FOIA-84-743

RESPONSE TO FREEDOM OF INFORMATION ACT (FOIA) REQUEST

#121 Subject: Report #2 - Quality Assurance Deficiencies in the Ultrasonic Measurement of Reactor Coolant Pressure Boundary Valves for Minimum Wall Thickness Requirements as Requested by the Atomic Energy Commission in their Letter of 6-20-72 to Pacific Gas and Electric Company at the Diablo Canyon Nuclear Plant.

III. Westinghouse Letter, pg 6

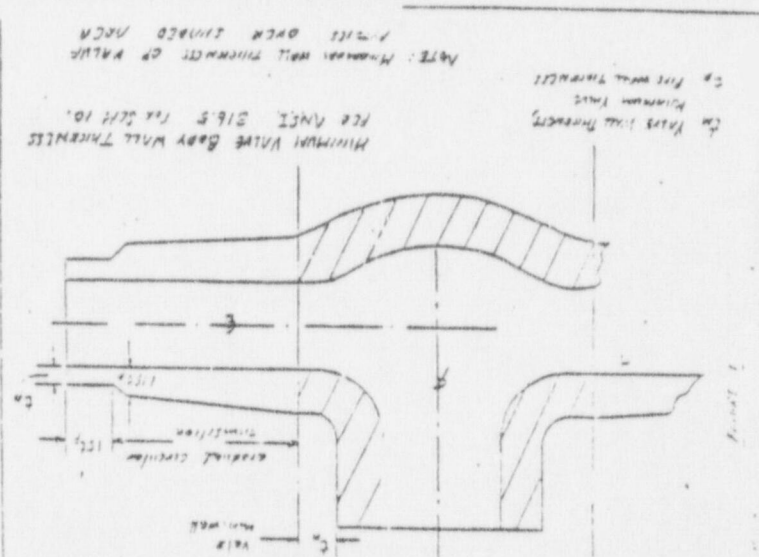
15" west of weld #WB293, Location # 2-8702 has an arc strike in the valve near the ID tag. Location # 1-8956-A, valve bonnet flange has two bolts that are not fully engaged with the nuts. Bolt #16 is approximately 2 nut threads below face of nut and bolt #10 is approximately 1 nut thread below the face of the nut.

Eleven Data Reports indicate "flat pad at bottom of casting inspected only for thickness". These reports had only two or three readings made and the valves were accepted based on these readings. This is a nonconformance to ESD 236.7.3.1 and Westinghouse letter # PG&E 2080, Figure #1 and Figure #2. The valve locations are:
